PLANNING, ZONING, & BUILDING DEPARTMENT
PZ&B Staff Combination Memorandum: Town Council and Architectural Commission

SUBJECT: ARC-23-094 (ZON-23-072) 241 WORTH AVE (COMBO)

MEETING: DECEMBER 15, 2023 ARCOM
JANUARY 10, 2024 TOWN COUNCIL

The applicant has submitted plans, entitled "Proposed Additions at 247 Worth Avenue" as prepared by **DJA Dailey Janssen Architects**, date stamped by the Town, December 01, 2023.

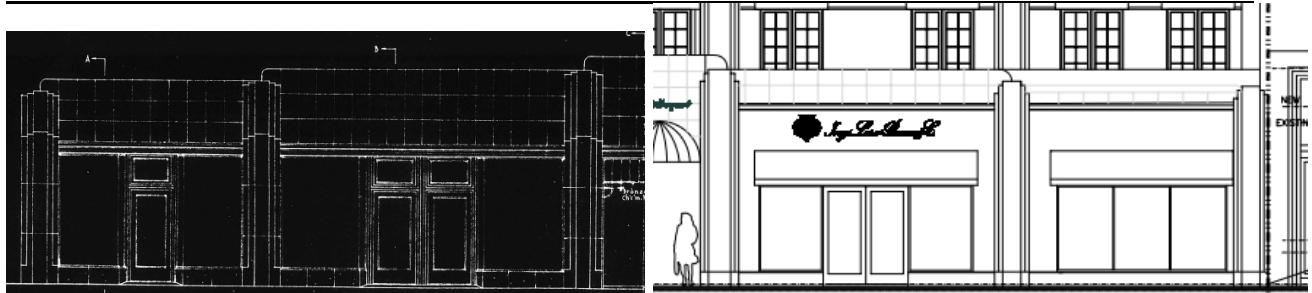
While a full restoration of the front façade of the existing building is not in the program due to very recent design alterations to three of the four bays, the applicant does intend on initially modifying the westernmost bay (Brioni) to recall aspects of the original design in the re-introduction of the fluted art deco pilasters.

It is the end goal for the entirety of the ground floor (Brioni, Yurman and Piana) to be restored to the original design as shown on sheet A-2.01 and illustrated below.

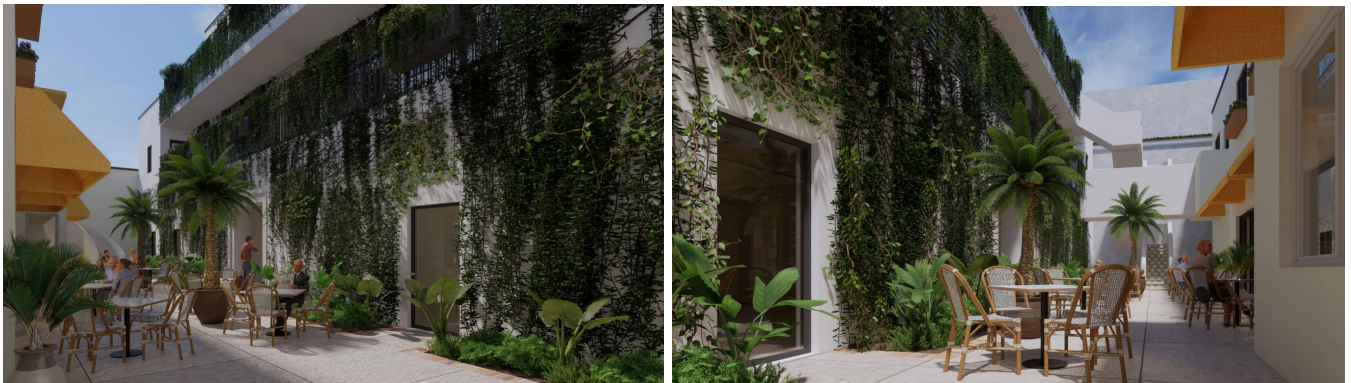
With that, the two-story addition takes many of the design cues from the original Art Deco design, most notably in the rhythm and the breakdown of the bays. The rear of the new construction consists open two upper levels of open-air walkways and catwalks as well as two new egress stairs with a vertical metal picket style railings. This rear façade shall not be visible from the right-of-way of across from the Peruvian Ave parking lot. However, while not a primary or secondary façade, the applicant has made considerable efforts to refine and improve this “rear facede”. There are two existing curvilinear stairs (that do not meet today’s code requirements for life safety) within the courtyard that provide access to the second floor of Le Bilboquet. These features are proposed to be demolished in order to address code compliant life safety and egress requirements as determined by the Fire Marshal. It must be noted that the applicant made numerous attempts to salvage both of these decorative features, but in the end, has managed to retain one of the stairs.

There is not much opportunity for the greening of the courtyard, or improving the nonconforming open space of the site, but the applicant has seized on the vertical nature of the proposal and has attempted to improve the aesthetic with a hanging garden, vertical landscaping approach.

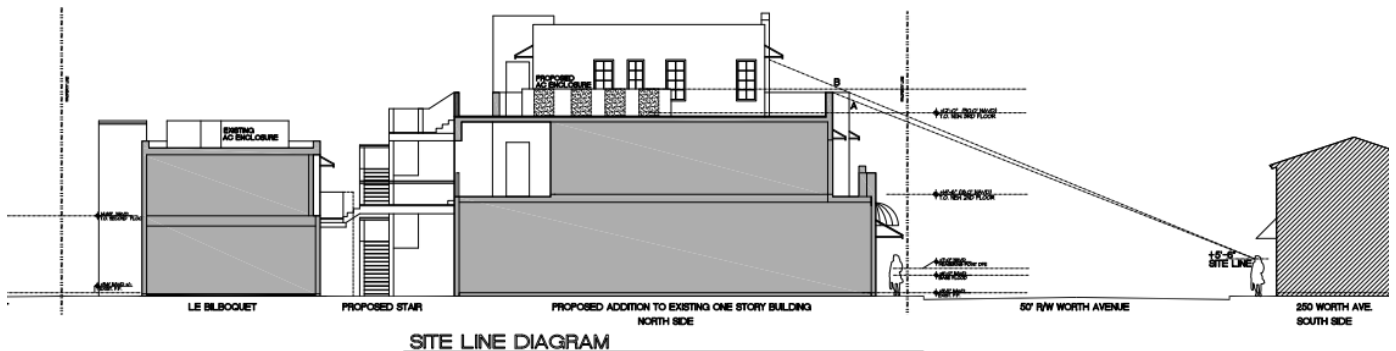
VARIANCE #4 [Sec. 134-2211\(a\)](#): Variance from the required minimum number of off-street loading spaces provided on-site. For new construction of commercial buildings between 4,000 SF and 25,000 SF of new area, one (1) on-site loading space is required. The new additions total 7,145 SF of new square footage to the 12,200 SF site.. The GIS map below illustrates the designated commercial loading zones, indicated in red, along Worth Avenue. As such, there are currently two dedicated on-street loading spaces for the 200 block of Worth Avenue, located to the south of the subject property.

Currently, the site has admittance for deliveries, trash pick-up and grease trap access through a cross-access easement from the owner of the Apollo parking lot that abuts the property to the north. If the variance is granted, staff recommends conditioning the approval on the same as well as specifying hours.

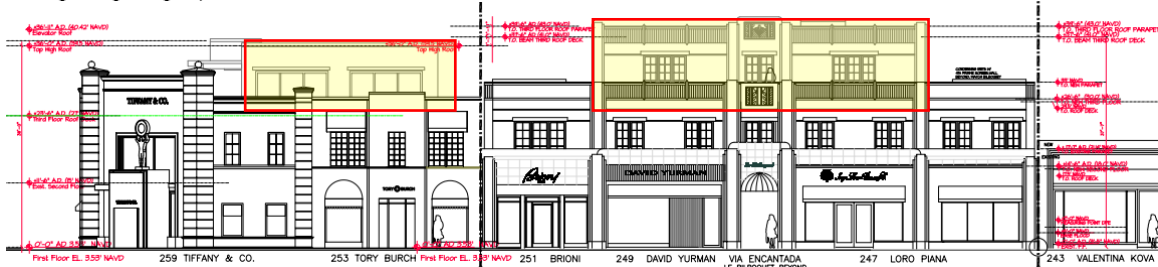
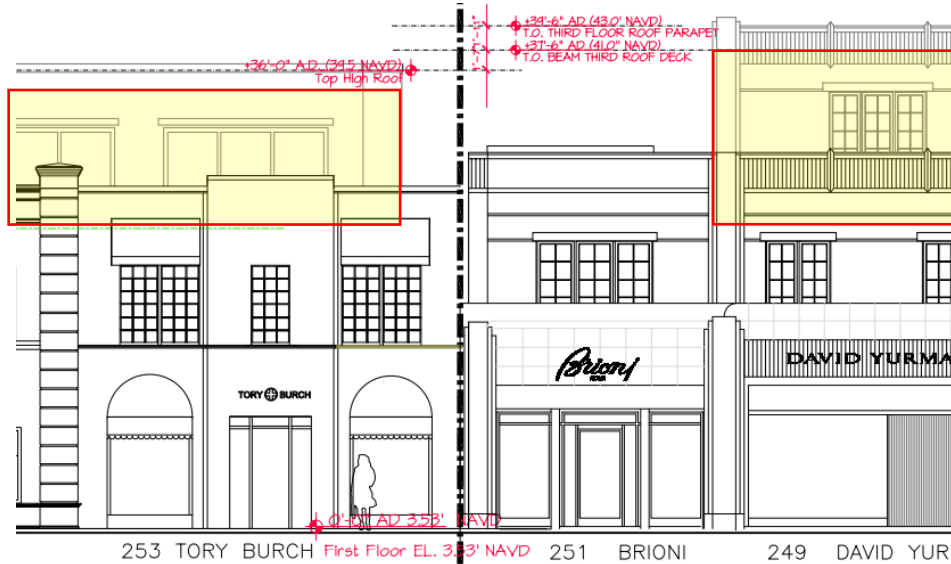
For comparison, the neighboring two-story building abutting the property to the west (the Tiffany building) received TC approval at the Nov 13, 2019 meeting for a special exception with site plan review and variance application in order to construct a third story as a special allowance based on the Worth Avenue Design Guidelines. That proposal consisted of a proposed third story with an enclosed 2,390 square feet of living space and active habitable roofdeck. The variance for the 720 square foot pergola which would allow a maximum third story coverage of 33% in lieu of the 25% lot coverage maximum allowed for a third story using the Worth Avenue Design Guidelines, pursuant to Z-19-00225. The ARCOM portion of that combo project was approved, pursuant to B-070-2019. That project (the Tiffany rooftop addition) was approved with a height of 36'-0" to the top of the third

floor roof (39.5 NAVD). This project is proposed at 39'-6" to the top of the third floor roof (43'-0" to top of parapet).

An enlarged elevation showing the second and third floor proposal as it relates to the abutting property to the west.

An enlarged elevation showing the second and third floor proposal as it relates to the abutting property to the east.
